PROJECT:
EXISTING SCHOOL SITE

1646 Alexis Road

DRAWING TITLE:
SEVERANCE PLAN

G APPENDIX G – COMMENTS

Site Plan

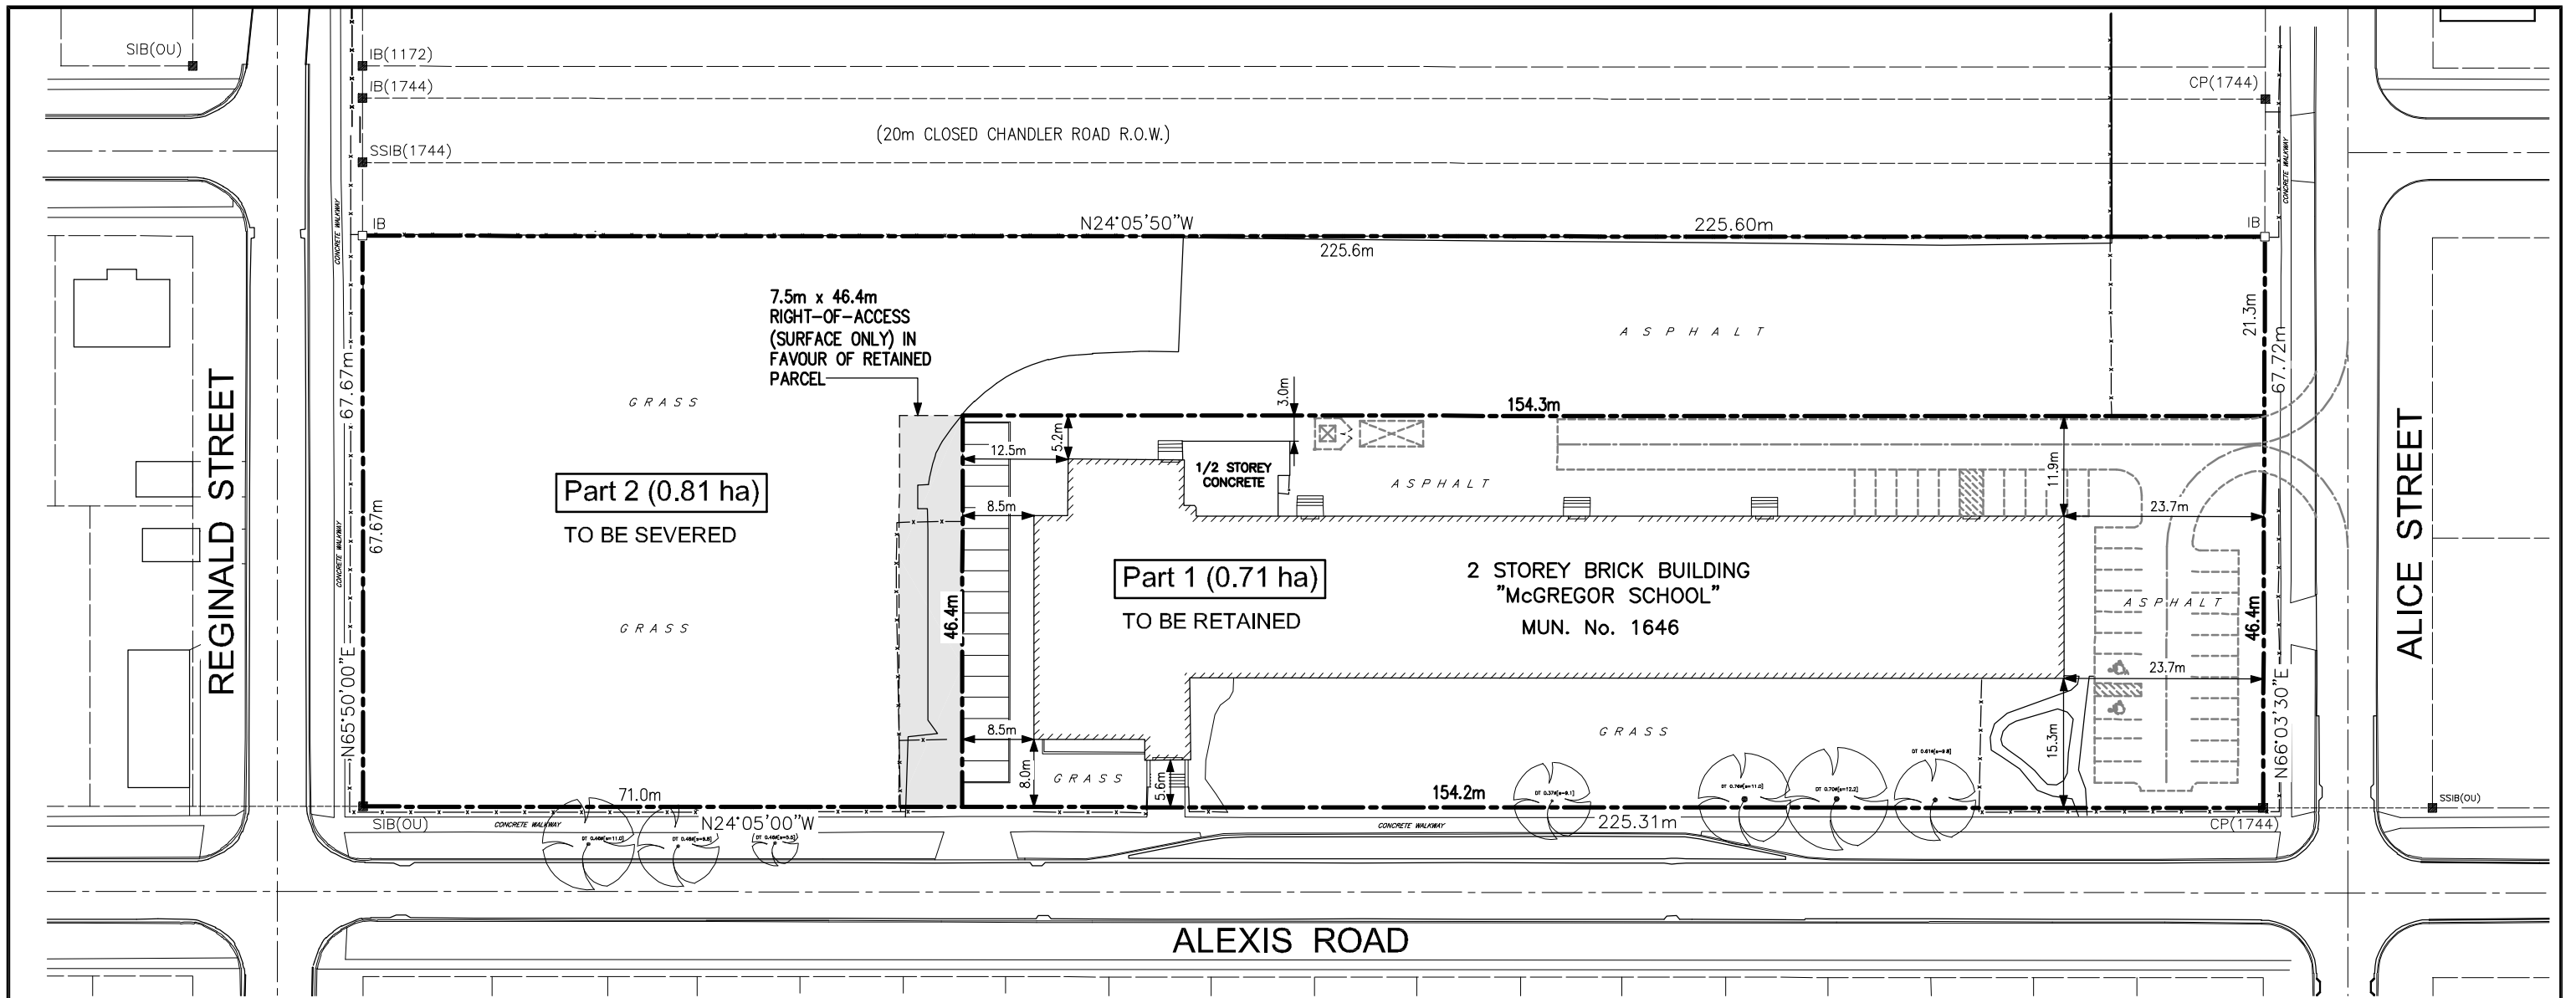
The site appears to have an existing fence and bumper blocks encroaching within the Reginald Street and Alice Street right-of-ways. The applicant will be required to remove or enter into an Encroachment Agreement for any items remaining in the right-of-way. If the property will be severed and shared services or access is proposed, a proper agreement between the two properties is required.

- Raised curbs not permitted within right-of-way
 - If a driveway access is being proposed from the retained parcel onto Alice St, then the existing driveway access onto Alice St must be removed and the boulevard restored.

- All driveway widths must be 7-9 metres total at the property line (minimum 3.5m/lane, maximum 4.5m/lane) and maximum 1 metre straight flare. Based on the site plan provided, the driveway proposed from the retained parcel onto Alice St has a width of 6 metres at the property line.

- Easternmost driveway access proposed onto Alice St must be a minimum of 15 metres away from the intersection of Alice St and Chandler Rd based on TAC Guidelines, unless proper justification can be provided.
